SUBMITTAL OF HANFORD FACILITY RESOURCE CONSERVATION AND RECOVERY ACT PERMIT MODIFICATION NOTIFICATION FORM 24590-LAW-PCN-ENV-17-008, SECONDARY OFFGAS/VESSEL VENT PROCESS SYSTEM

The purpose of this Class 1 prime permit modification is to submit revisions to Piping and Instrumentation Diagrams for the Low-Activity Waste Secondary Offgas/Vessel Vent Process System equipment in Appendix 9.2 of Reference 1.

**Hanford Facility RCRA Permit Modification Notification
Form 24590-LAW-PCN-ENV-17-008**

24590-LAW-PCN-ENV-17-008

**P&ID - LAW
LAW MELTER FEED
PROCESS SYSTEM
MELTER 1 FEED VESSEL
LFP-VSL-00002**

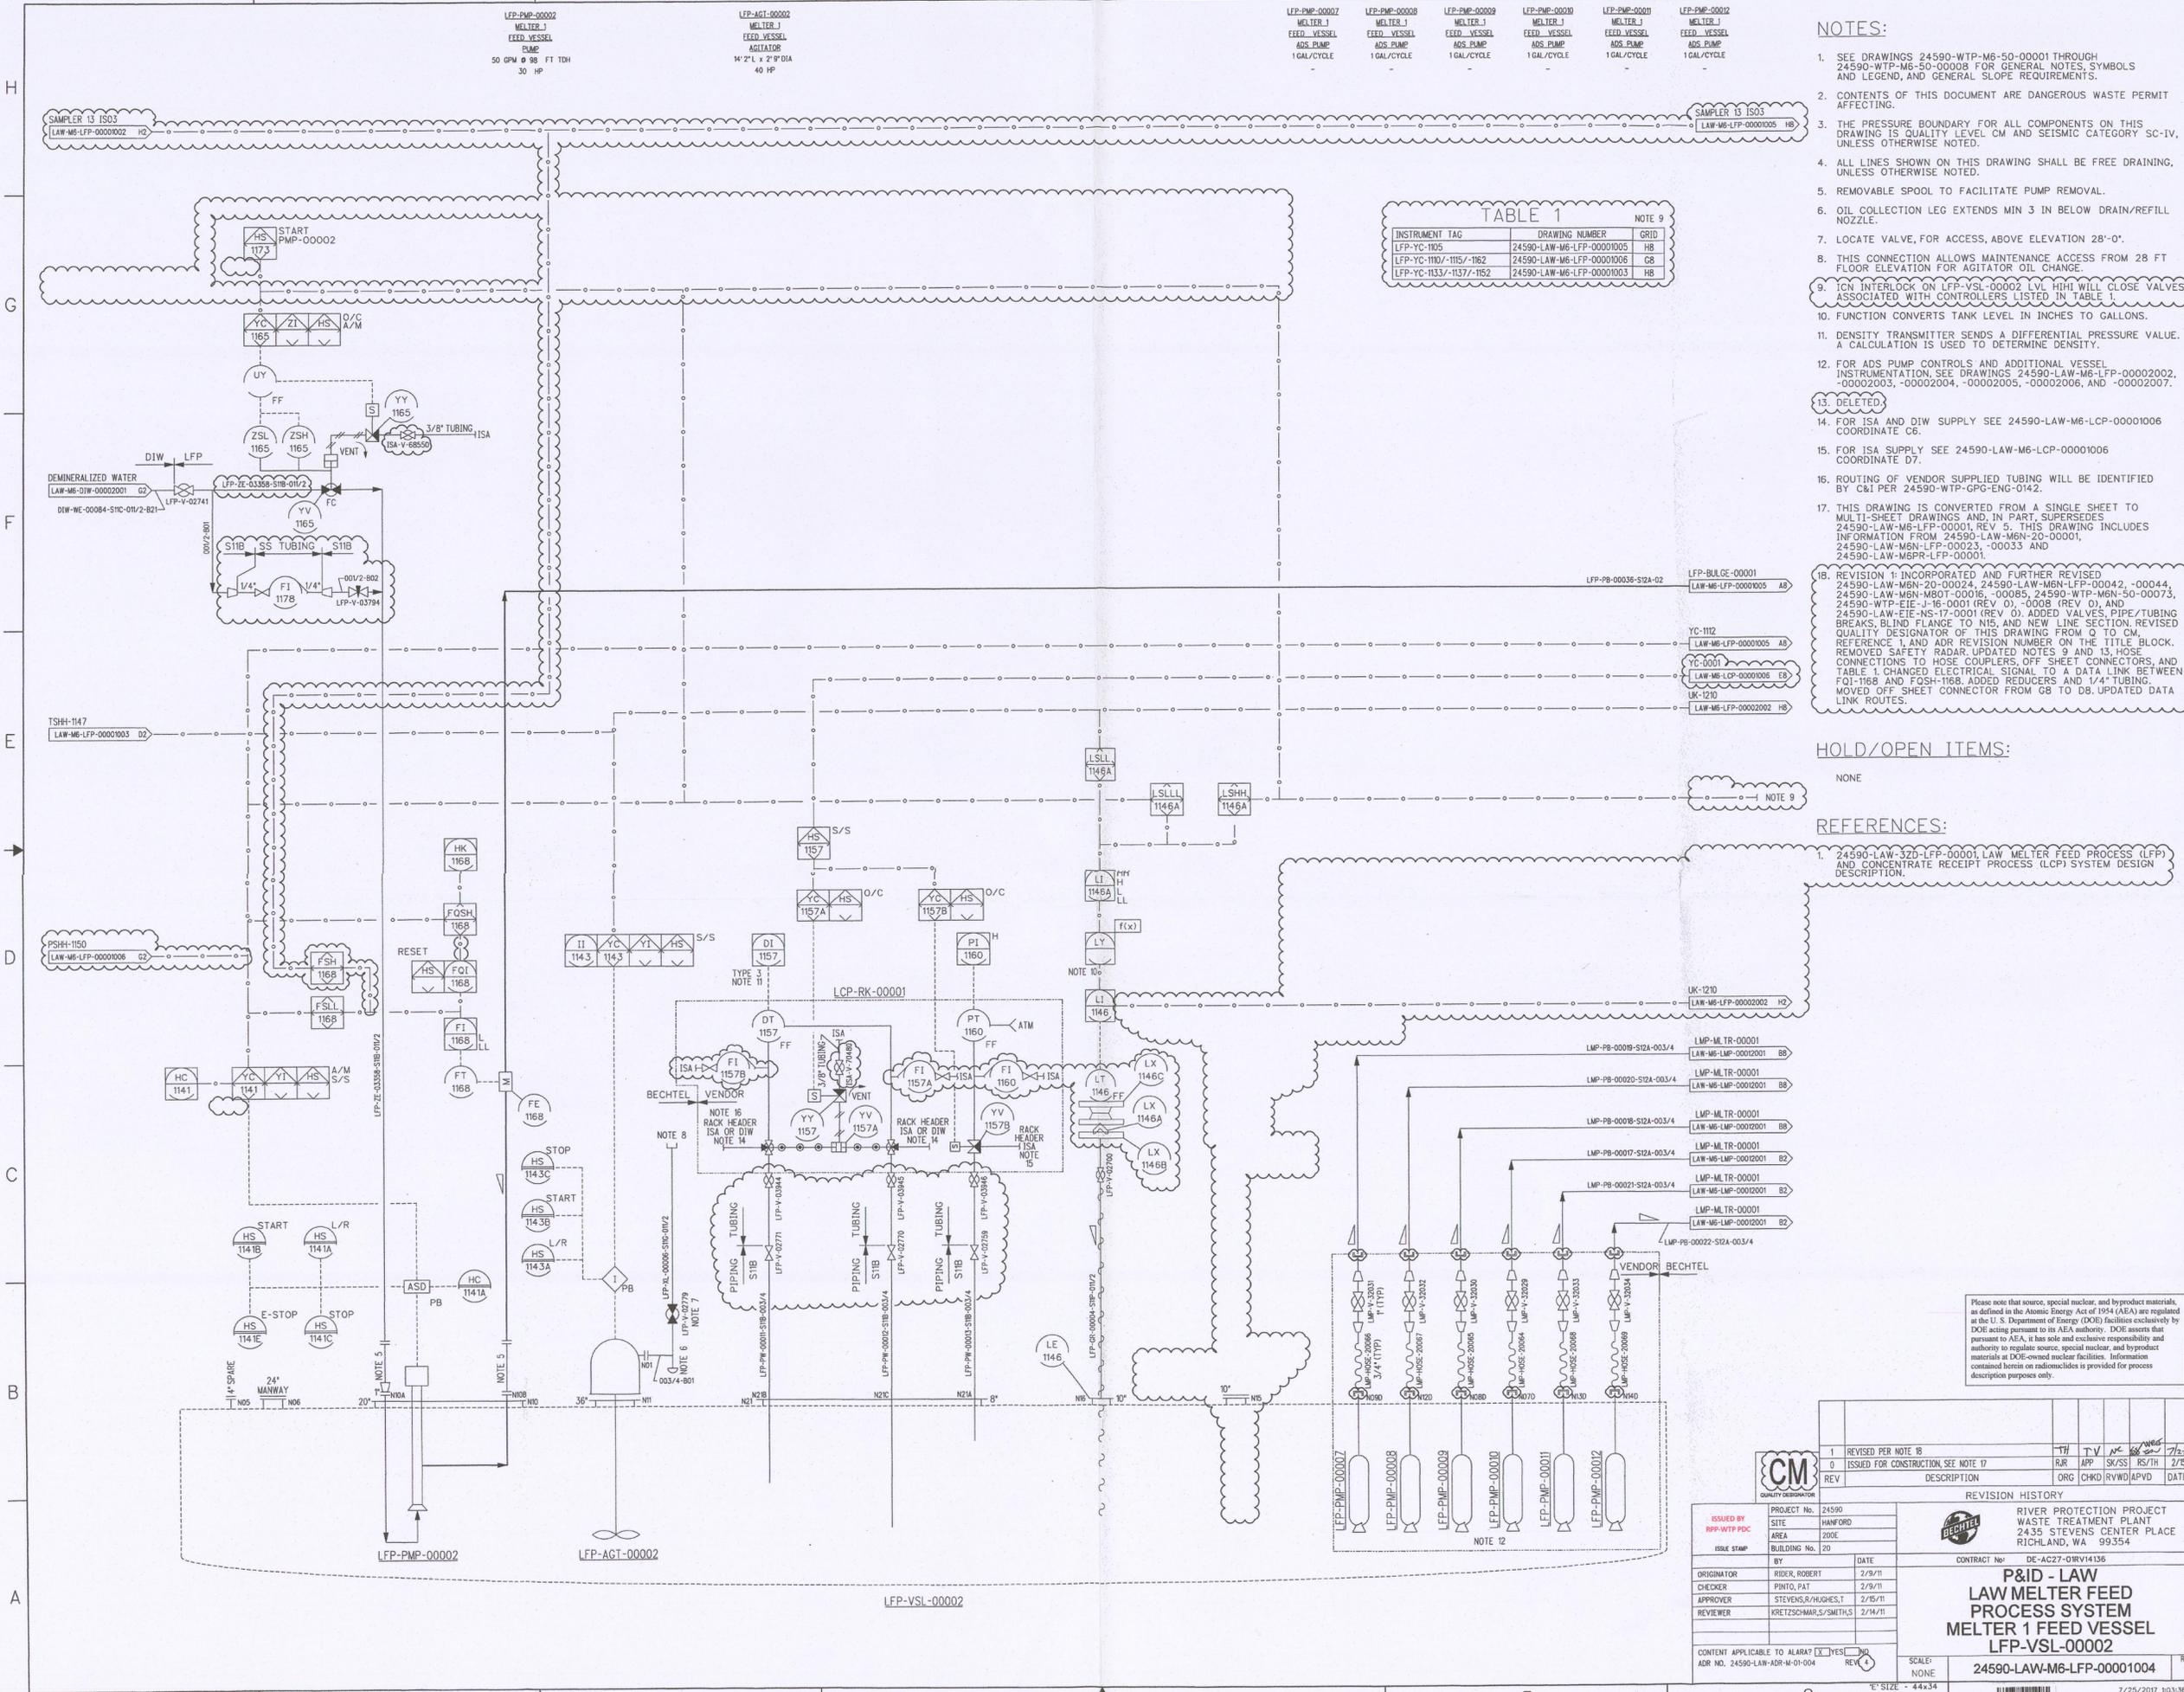
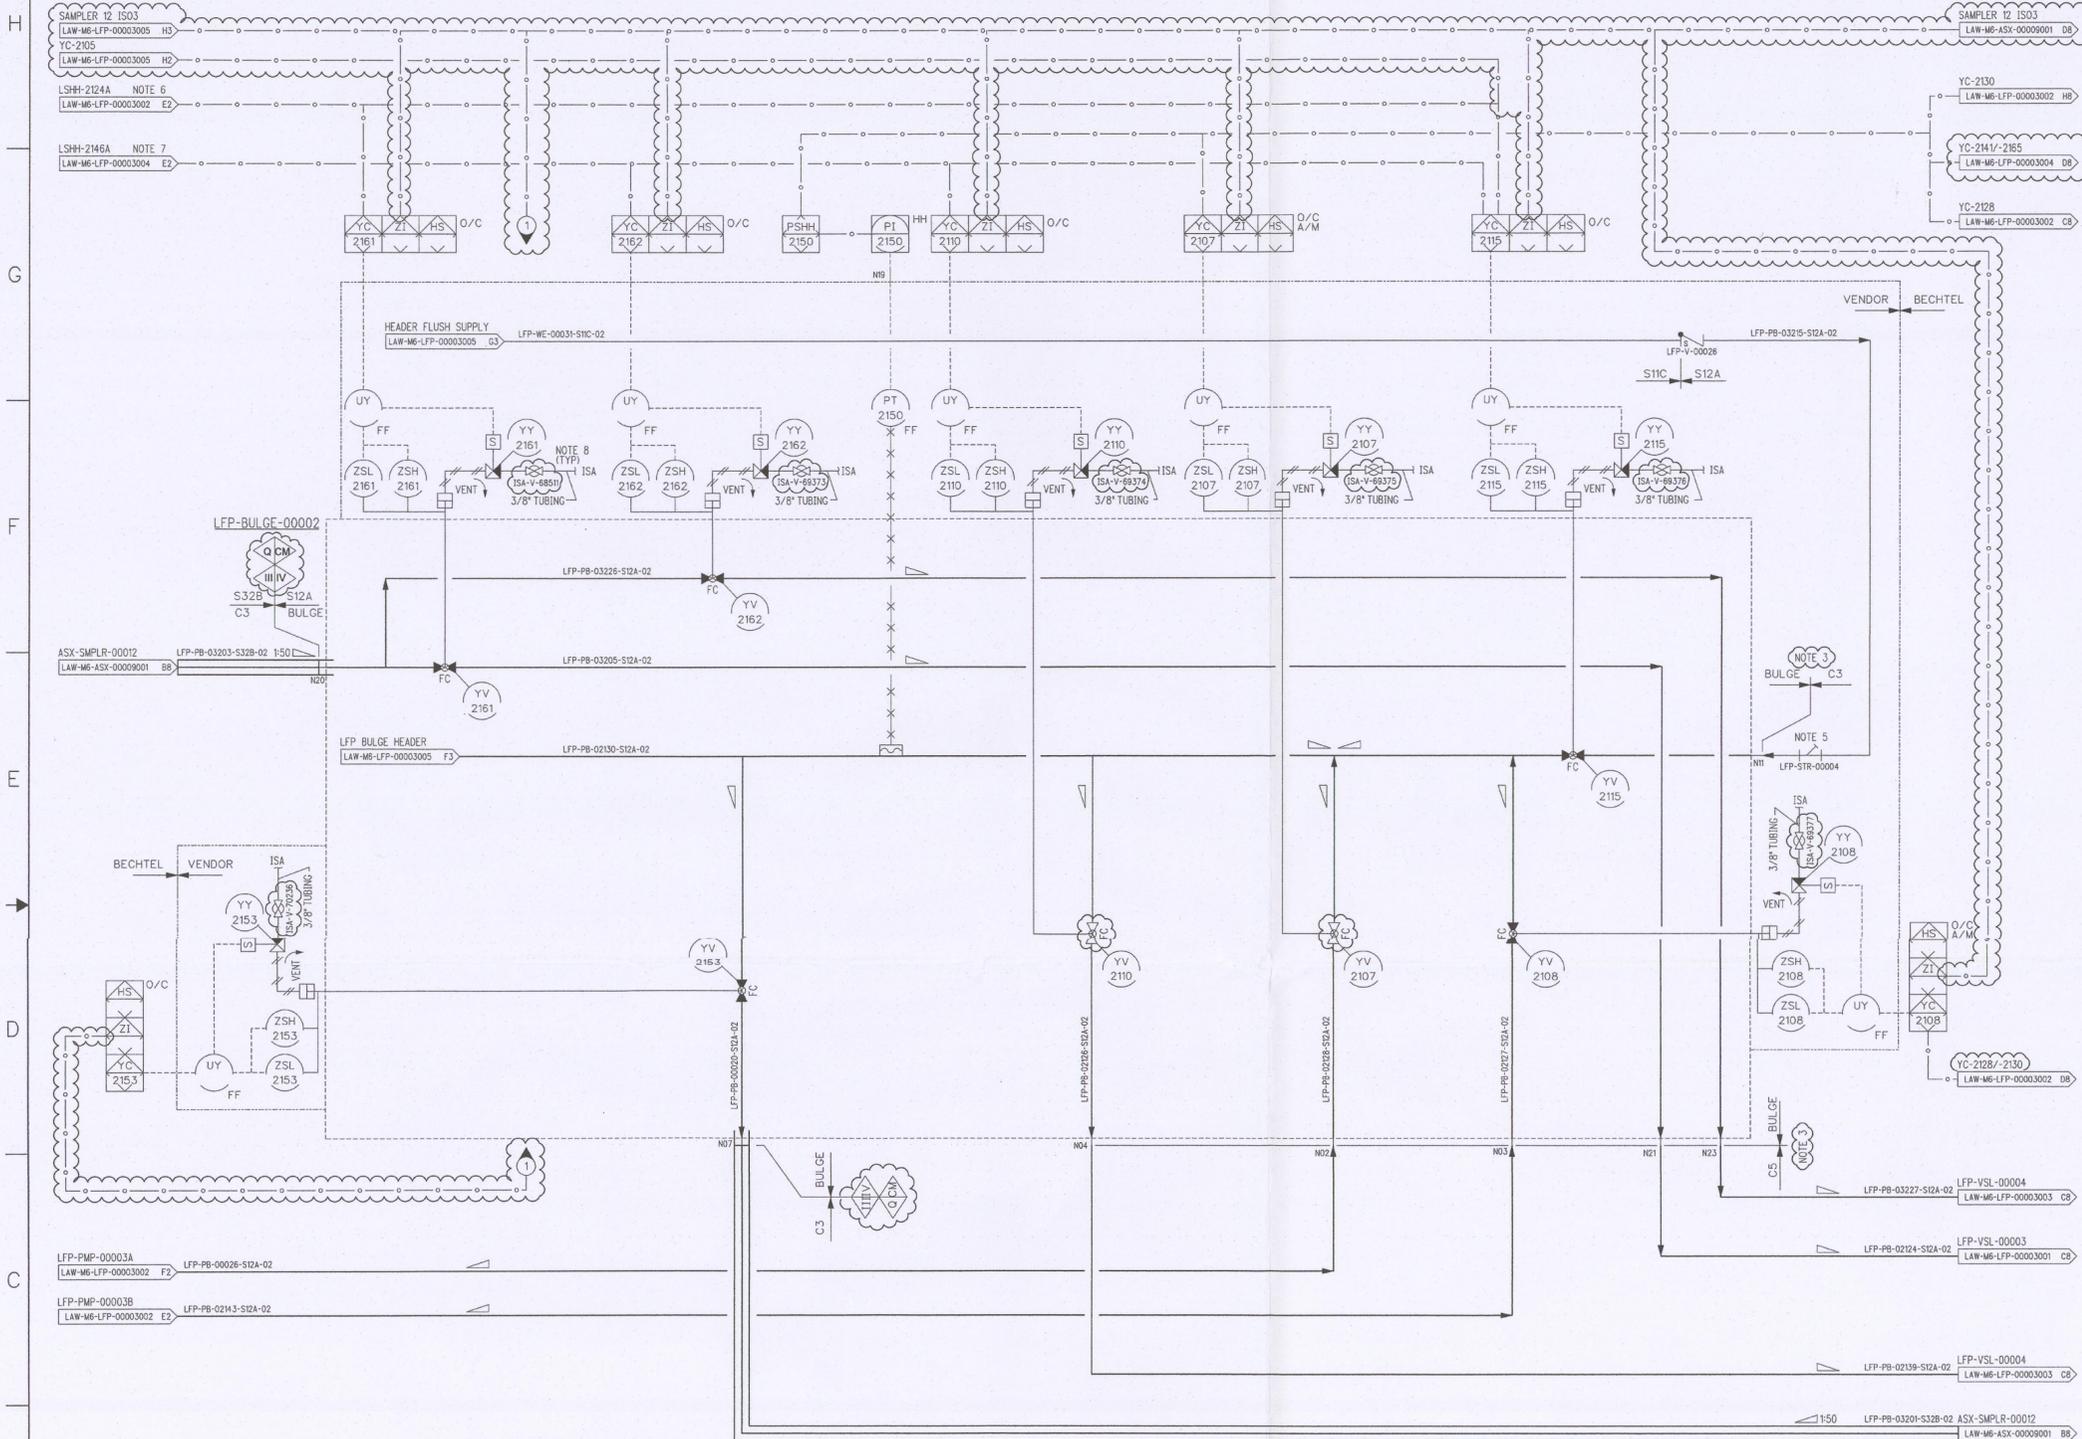
Changes to the P&ID (24590-LAW-M6-LFP-00001004, Rev.1) for the Melter 1 Feed Process System Feed Vessel LFP-VSL-00002 are summarized below:

- Added or modified notes in the Notes section. Revised the References section.
- Added Valves, Pipe/Tubing Breaks, Blind Flange to N15, and a new Line Section (Grid4).
- Revised Quality Designator of this drawing from Q to CM.
- Updated Note 9 to read: JCN Interlock on LFP-VSL-00002 LVL HI HI Will Close Valves Associated with Controllers Listed in Table 1.
- Removed Safety Radar (Note 13).
- Changed electrical signal to a data link between FQI-1168 and FQSH-1168.
- Added reducers and ¼" Tubing.
- Moved Off-Sheet Connector from G8 to D8.

- REVISION 1 INCORPORATED AND FURTHER REVISED 24590-LAW-M6-MN-20-00024, 24590-LAW-M6-MN-LFP-00042, -00044, 24590-LAW-M6-MN-MBT-00016, -00085, 24590-WTP-M6-50-00073, 24590-WTP-EIE-J-16-0001 (REV. 0), -0008 (REV. 0), AND 24590-LAW-EIE-NS-17-0001 (REV. 0). ADDED VALVES, PIPE/TUBING BREAKS, BLIND FLANGE TO NIS, AND NEW LINE SECTION. REVISED QUALITY DESIGNATOR OF THIS DRAWING FROM Q TO CM. REFERENCE 1, AND ADR REVISION NUMBER ON THE TITLE BLOCK. REMOVED SAFETY RADAR. UPDATED NOTES 9 AND 13. HOSE CONNECTIONS TO HOSE COUPLERS, OFF SHEET CONNECTORS, AND TABLE 1 CHANGED ELECTRICAL SIGNAL TO A DATA LINK BETWEEN FOI-1168 AND FOSH-1168. ADDED REDUCERS AND 1/4" TUBING. MOVED OFF SHEET CONNECTOR FROM G8 TO D8. UPDATED DATA LINK ROUTES.
